Groundwater Application Review Summary Form

Application # G- 19423

GW Reviewer Phillip I. Marcy Date Review Completed: 07/02/2025

PUBLIC INTEREST REVIEW FOR GROUNDWATER APPLICATIONS

Water-Level Measurements in Nearby Wells

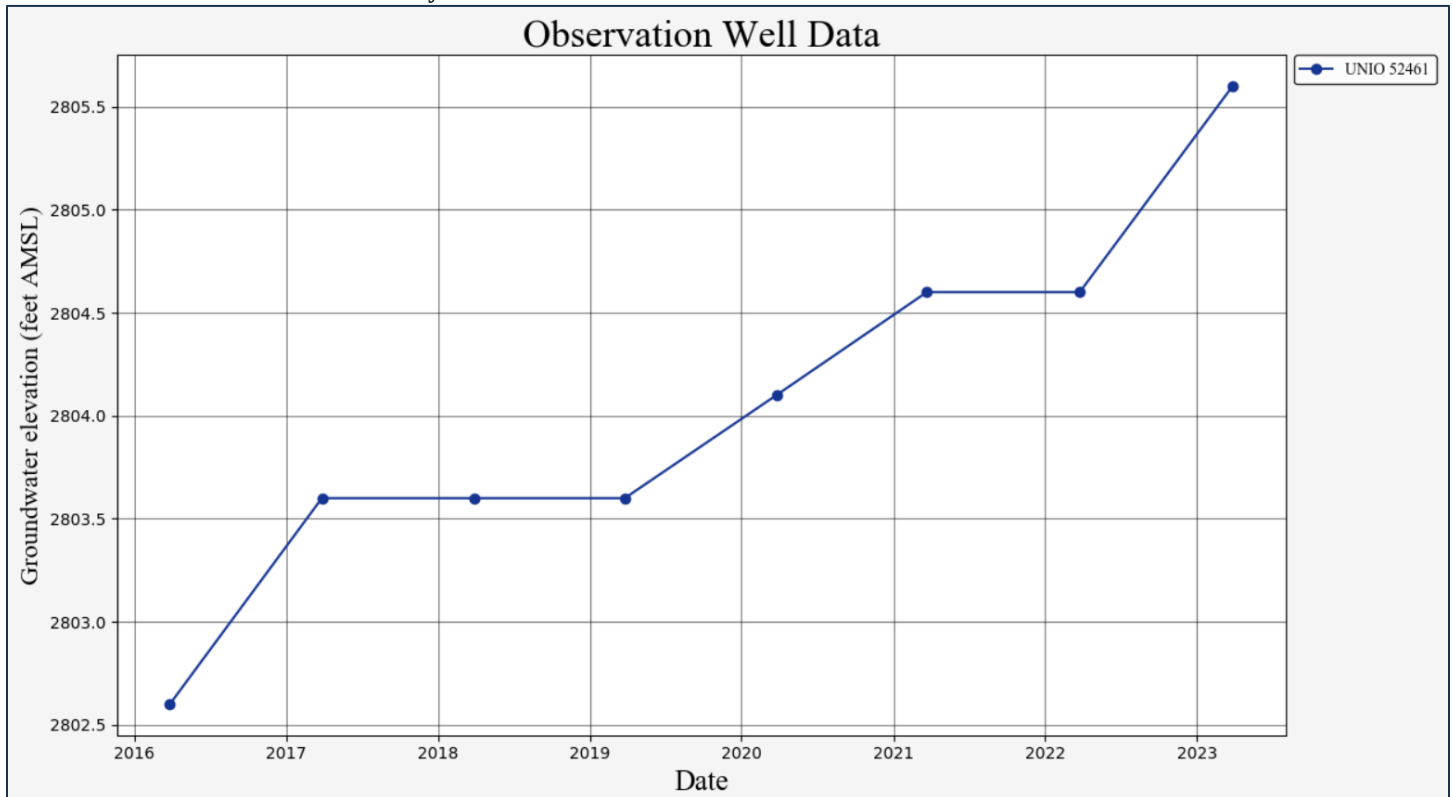
The proposed POA is the only nearby well known to penetrate the productive aquifer and with relevant measurements. Reported permit condition measurements do not suggest declines.
